ENGINE - FUEL AND CONTROL - INCREASE LENGTH BOLTS FOR ELECTRONIC ENGINE CONTROL (EEC)  
GROUND CABLE STRAP - CATEGORY CODE 6 - MOD.ENG-73-0031

- (1) Aircraft: Airbus A320
- (2) Engine: V2500-A1 Engines before Serial No.V0180

V2500-ENG-73-0031

Location of EEC Ground Strap Cable Bolts  
Fig.1

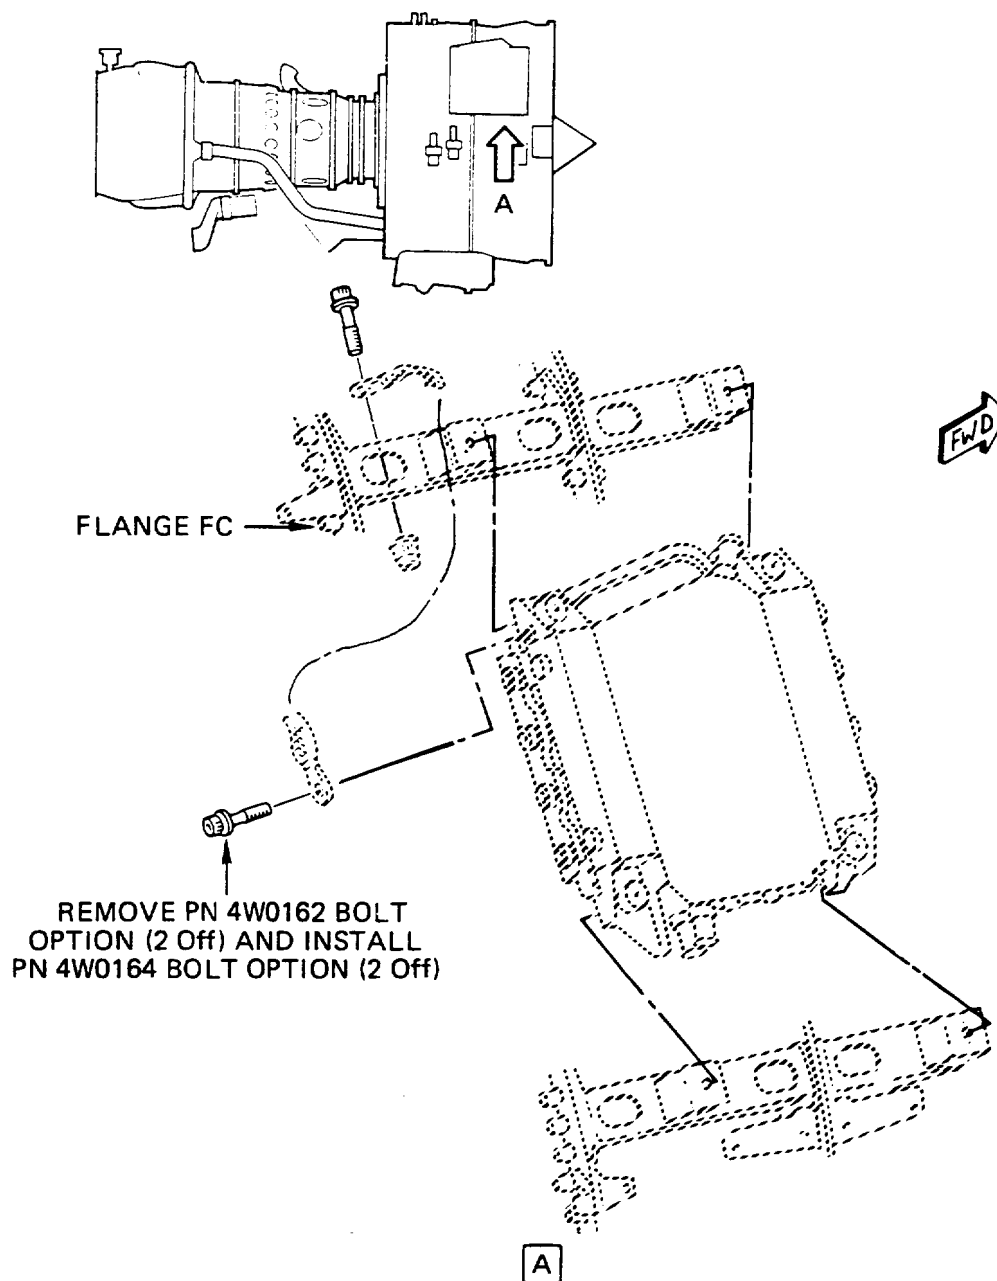
The Bolts that support the Electronic Engine Control (EEC) Ground Cable Strap may have insufficient length.

Some Ground Cable Strap attaching Bolts may not have an adequate projection length.

Provide longer Bolts for supporting the EEC Ground Cable Strap to its Support Bracket and EEC Housing.

- (1) Provide a longer Bolt to attach the Ground Cable Strap to the EEC Support Bracket.

- (2) Provide a longer Bolt to attach the Ground Cable Strap to the EEC Housing.

- (1) Replace the 4W0162 Bolt Option with the 4W0164 Bolt Option (1 off) on the Ground Cable Strap attachment to the EEC Support Bracket by the approved procedure in Reference (2), Chapter/Section 70-00-32, Installation-01. Refer to Figure 1.
- (2) Replace the 4W0162 Bolt Option with the 4W0164 Bolt Option (1 off) on the Ground Cable Strap attachment to the EEC Housing by the approved procedure in Reference (2), Chapter/Section 70-00-32, Installation-02. Refer to Figure 1.
